COMPARATIVE ANALYSIS OF THE 1990 SOUTH BROADWAY SECTOR DRAINAGE MANAGEMENT PLAN BY BOHANNAN-HUSTON, INC. AND THE 2013 SOUTH BROADWAY DRAINAGE & WATER QUALITY MANAGEMENT PLAN BY URS

<p>0 1,500 3,000 Feet 1 : 36,000 or 1 inch = 3,000 Feet</p> <p>URS</p> 	<p>Legend</p> <ul style="list-style-type: none"> Study Area Major Road Railroad City Boundary Pond 	<p>Study Area Limits</p> <p>South Broadway Drainage and Storm Water Quality Management Plan</p> <p>Figure E-1</p>
---	--	---

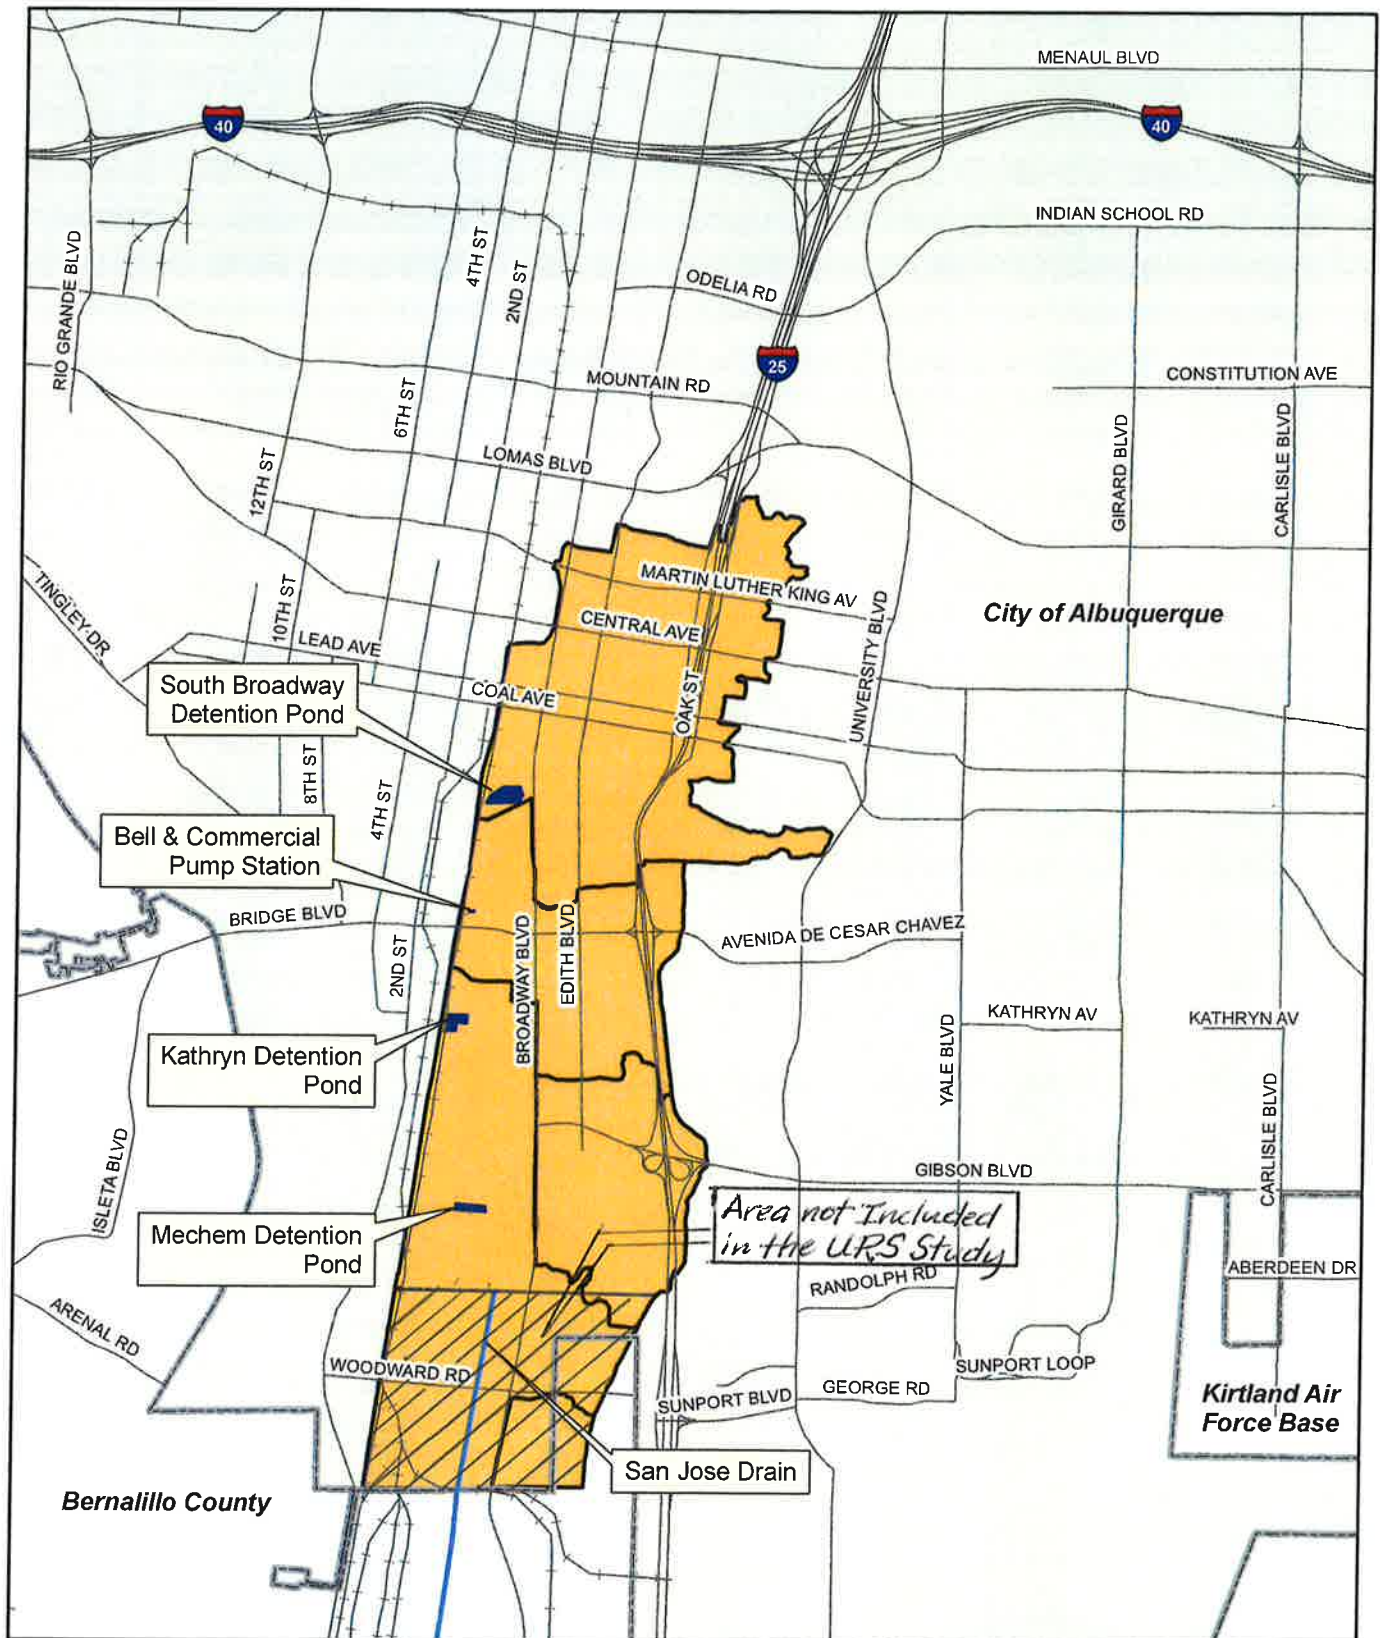
It is important to note that the URS study did not extend its SWMM model as far south as the BHI model (refer to *Figure E-1* which indicates the approximate area not included in the URS study). Also as can be seen on the *Plate 11* exhibit BHI recommended a pond location in the vicinity of Woodward and the San Jose Drain. As explained in more detail below in the section entitled “Impacts to the San Jose Drain” the URS study reported release rates from the South Broadway study area for Recommended Improvements 1 through 5 that would exceed the maximum capacity of the San Jose Drain reported by BHI in 1990.

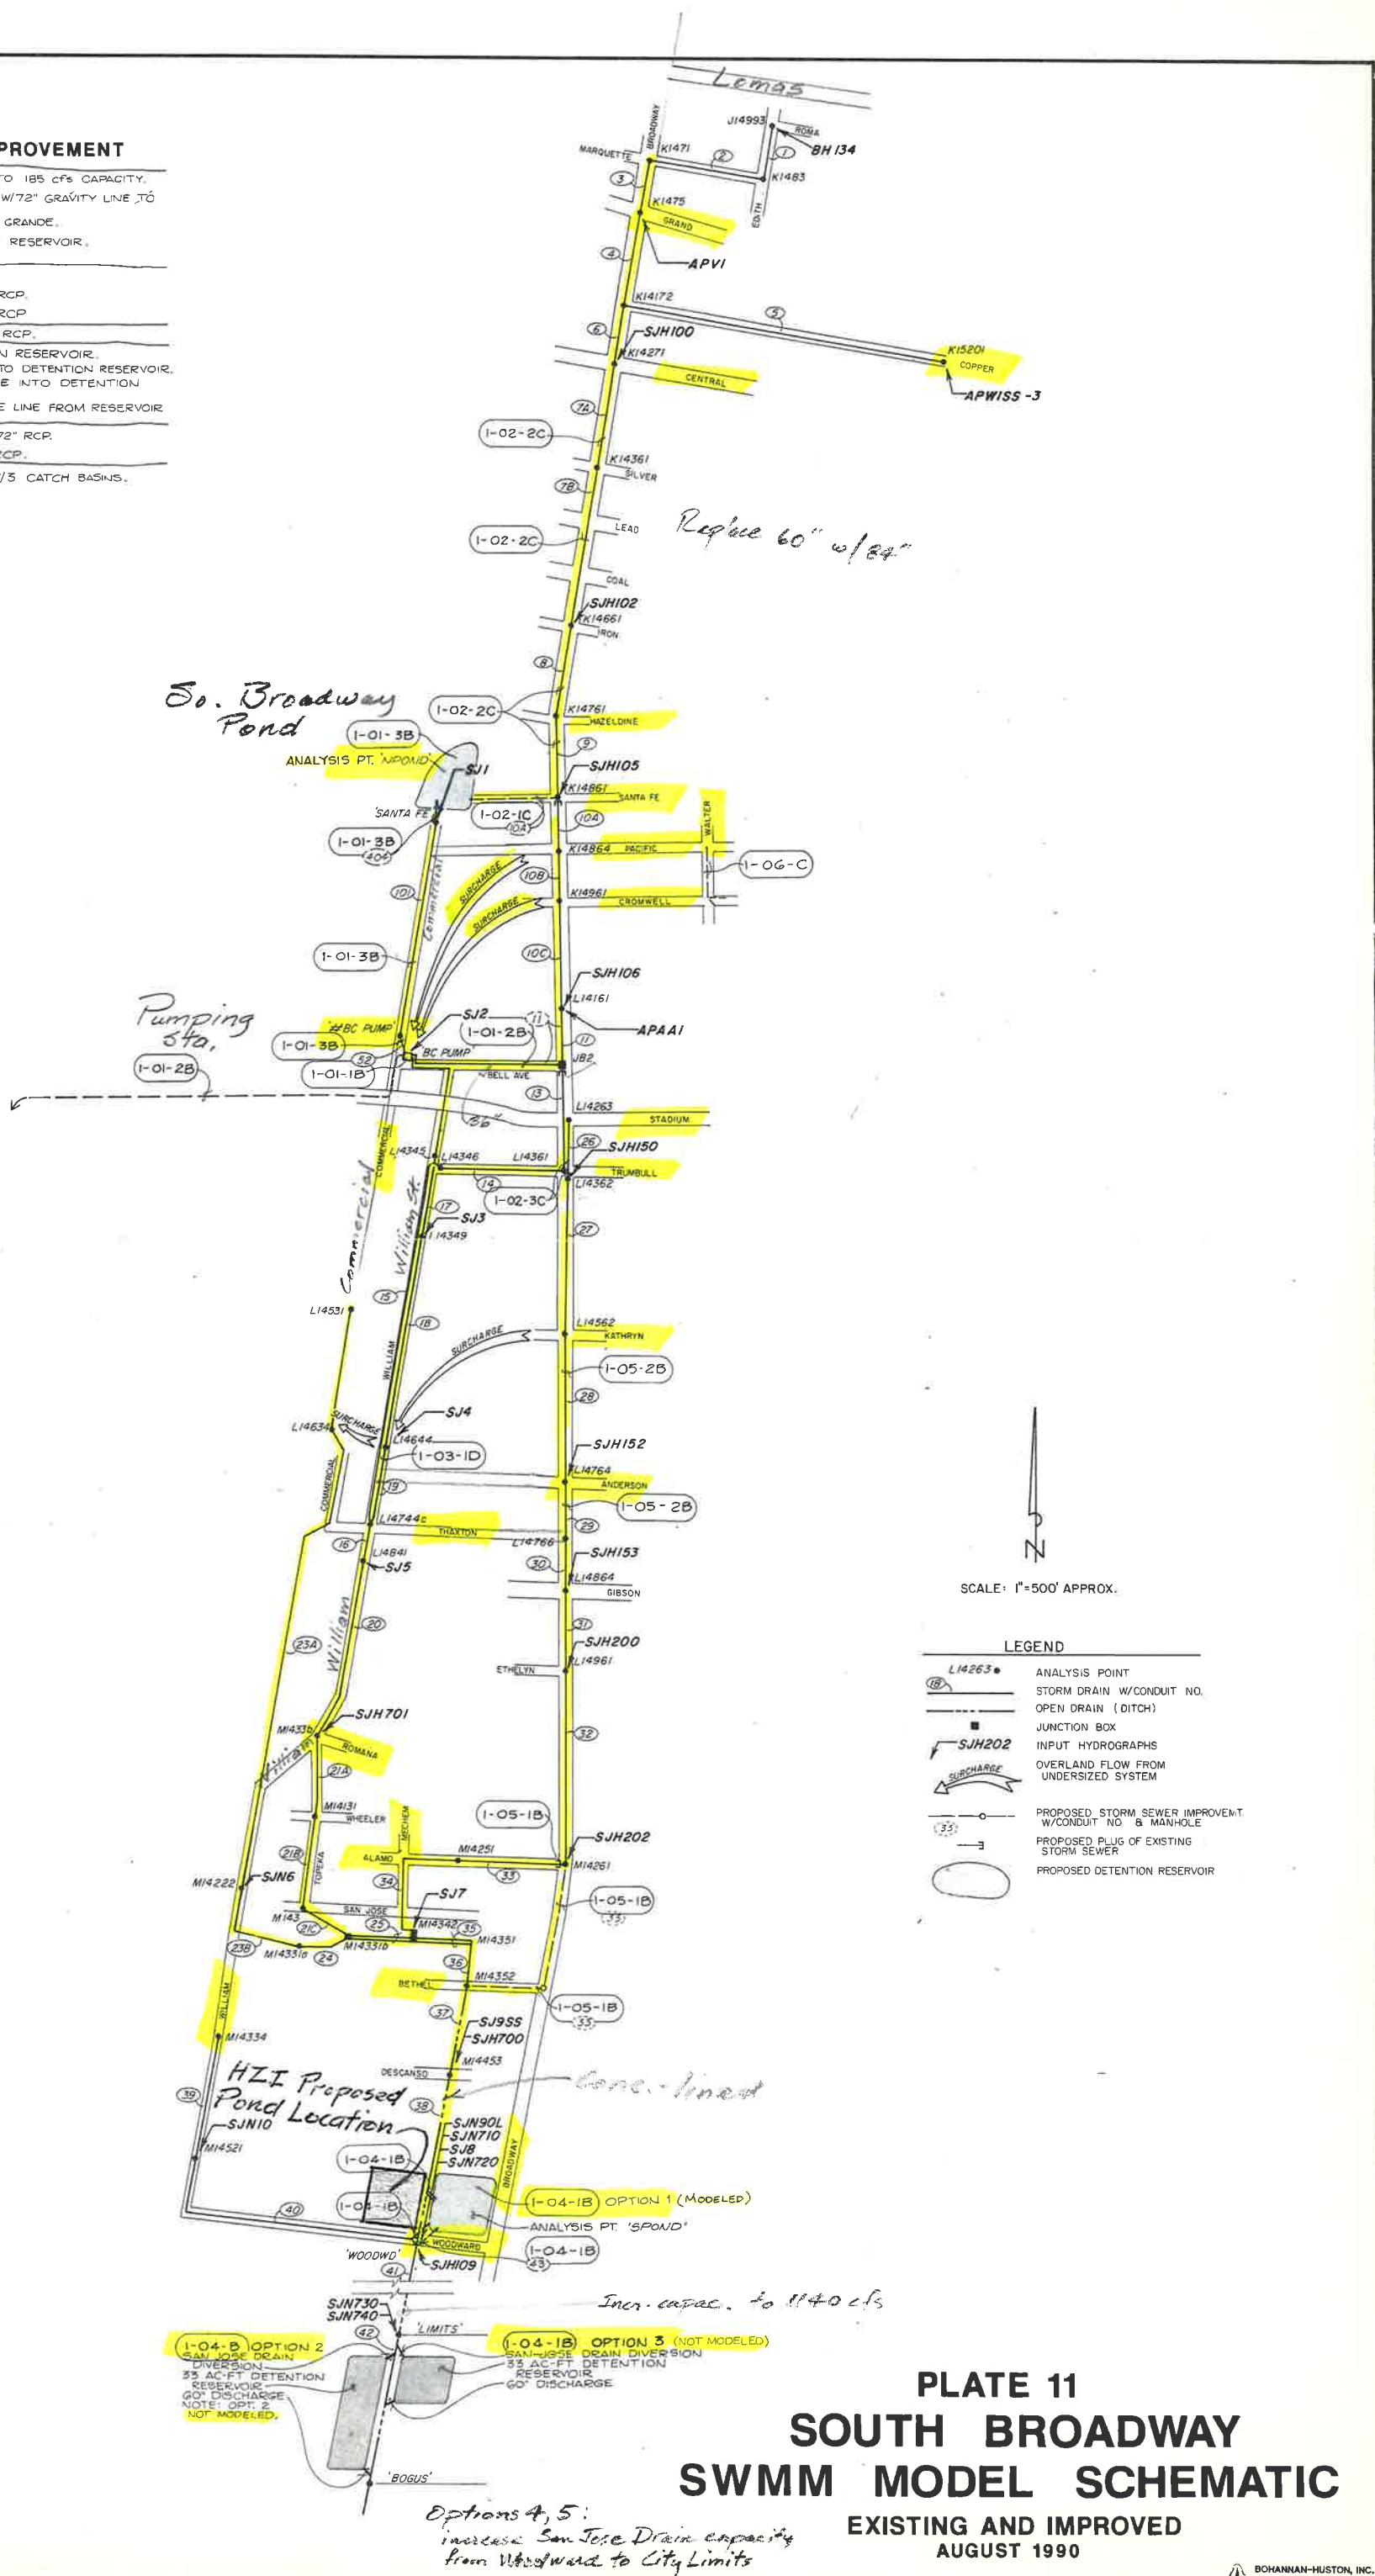
In order to avoid flooding of the San Jose Drain it is strongly recommended that a South Detention Pond as suggested by BHI in 1990 be constructed. BHI suggested three locations for the South Detention Pond. Current constraints would make it difficult to construct a South Detention Pond

at the locations indicated by Options 1, 2, and 3 of the BHI study. Recognizing the need of this detention facility Huitt-Zollars recommends the construction of a pond at a new location just west of the Option 1 location at the northwest corner of the intersection of Woodward and the San Jose Drain. Refer to *Plate 11* and *Figure D.4* for the proposed location of the South Detention Pond.
